# CITY OF ISANTI PLANNING COMMISSION MEETING TUESDAY, July 21, 2020 Immediately Following the 7:00pm City Council Meeting CITY HALL

Site Plan Review for Serenity Circle Counseling office building located at 201

Serenity Circle Counseling - 201 Main Street - Plan Review

We have reviewed the plan entitled "Serenity Circle Counseling" with a signature date of 6/19/2020.

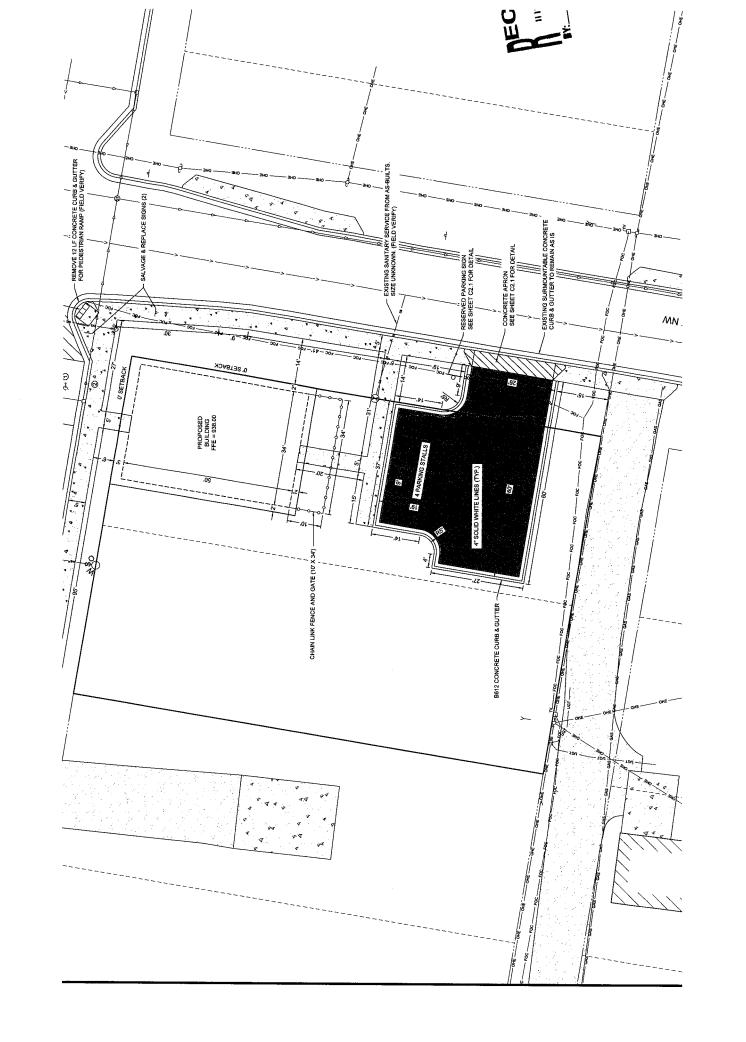
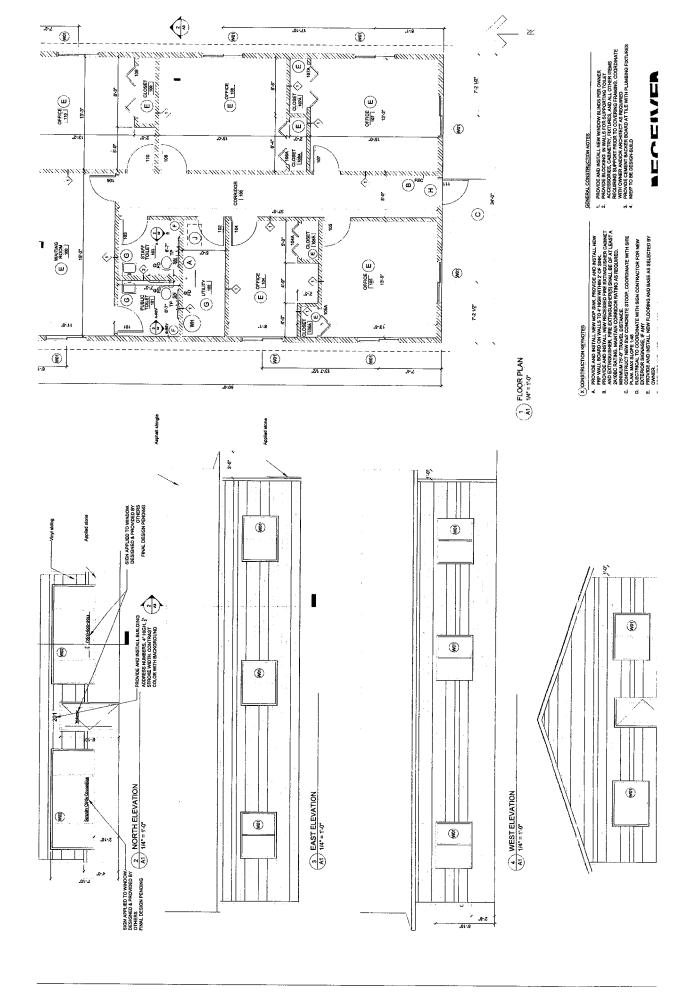
Sidewalks are proposed along the front and the east sides of the building, which will run parallel to the existing streets, extending the existing sidewalk network in the downtown district. The proposed sidewalks are intended to be 5 feet in width. The City Engineer's Memo explains that the sidewalk should be 6 feet wide when against the back of a curb, which would apply along Main St, 2<sup>nd</sup> Ave NW and the parking lot.

The location for trash receptacles is not identified on site plans. The site plans display a chain link fence with a gate along the south side of the proposed building, which could enclose the trash receptacles, but must be identified on the site plans. Lighting for the trash enclosure area is provided by the wall sconces on the exterior of the building.

- 1. Add crosswalk blocks across Main Street to the north and blocks across 2<sup>nd</sup> Avenue to the East.
- 2. The sidewalk should be 6 feet wide when against the back of curb, this applies along Main Street, 2<sup>nd</sup> Avenue, and the parking lot.
- 3. Relocate all signs into the green space behind the sidewalk.
- 4. Move the handicap stall into the parking lot.
- 5. At west end of sidewalk along Main Street, flair walk out to match into the flat portion of the existing driveway apron.

- The applicant shall enter into a minor development agreement.
- Signs require a sign permit before installation.
- A landscaping plan shall be provided for review of planting locations and species as part of the development agreement.
- The location of trash receptacles must be identified on site plans as part of the development agreement (if stored outside).
- Applicant shall apply for all permits associated with the building including a building permit, mechanical permit, plumbing permit, electrical permit, and sewer and water hookup.

- A Utilities Plan shall be provided to determine the locations for lines placed underground as part of the development agreement.
- All other conditions listed in the City Engineer's memo, dated 7/1/2020
